## **REQUEST FOR TENDER No. 26-023**

### **River's Edge Water Quality Improvement**

#### **Addendum 2**

**Issued: June 16, 2026**

PROJECT:	
<b>RIVER'S EDGE WATER QUALITY IMPROVEMENT</b>	
DWG NO:	<b>P5.2</b>
REV:	<b>#</b>

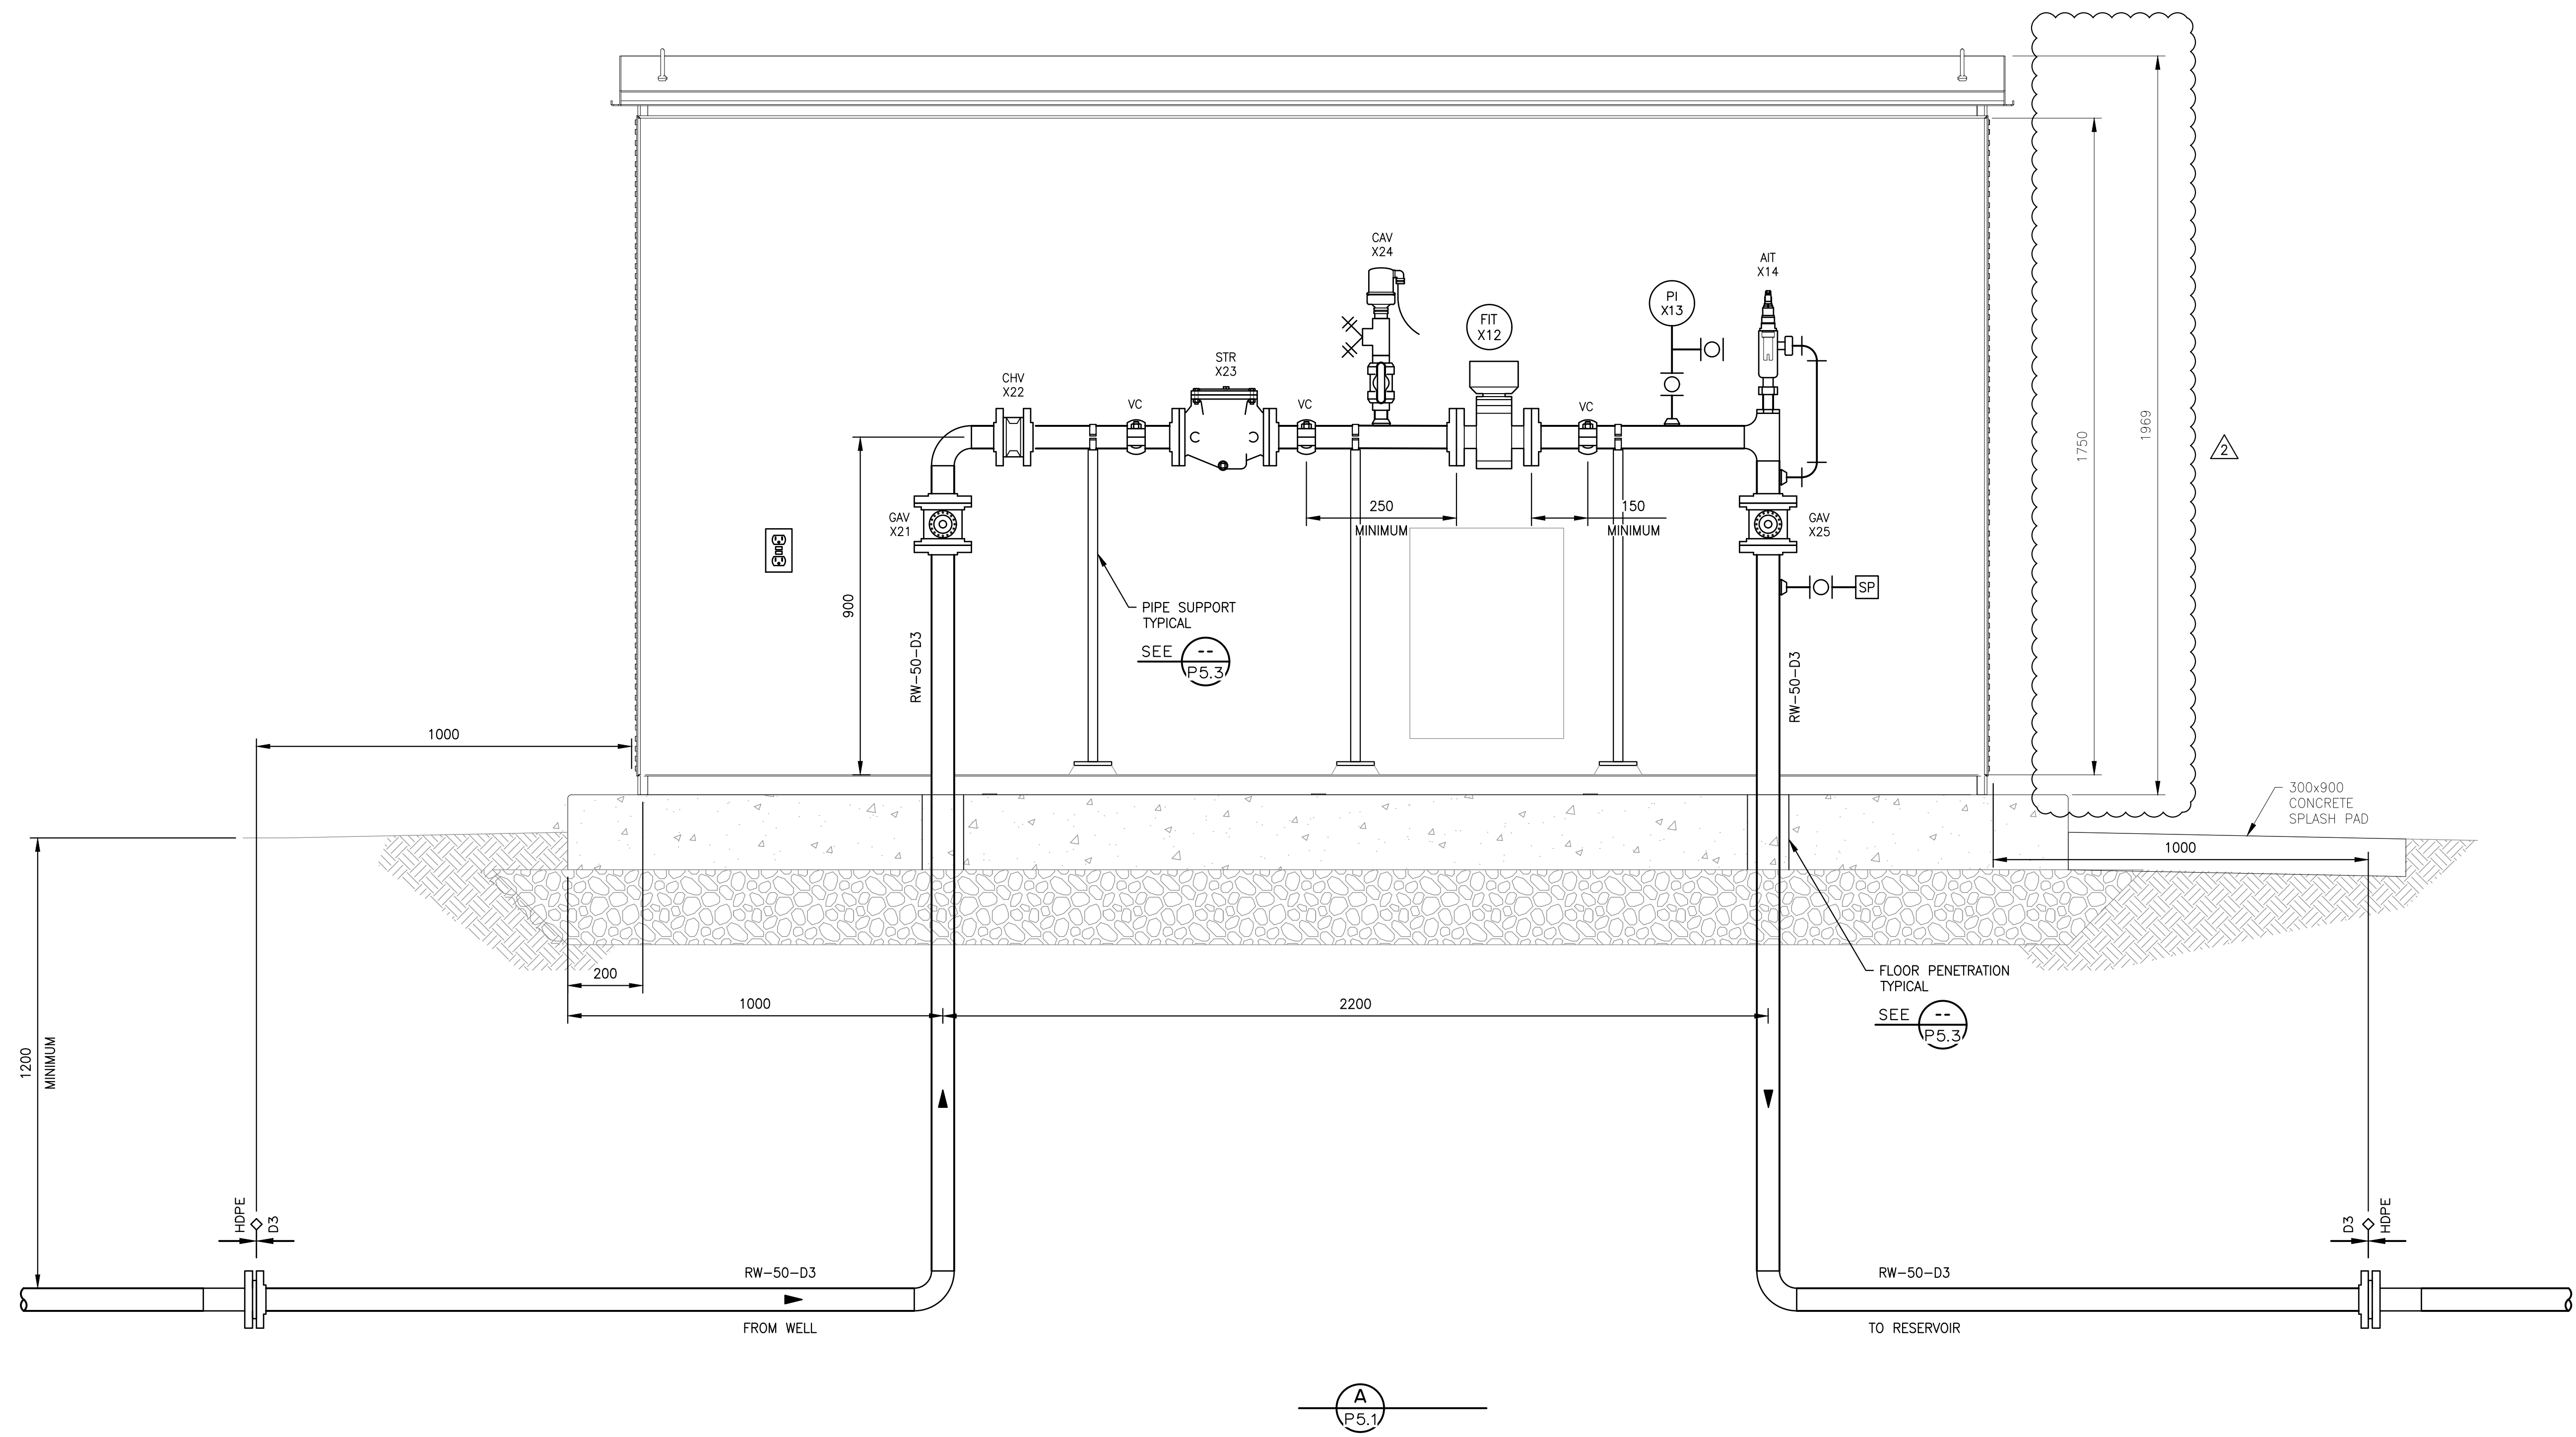
**6. Drawing P 5.2 – Process Typical Well Kiosk Section**

Replace: Drawing with the attached.
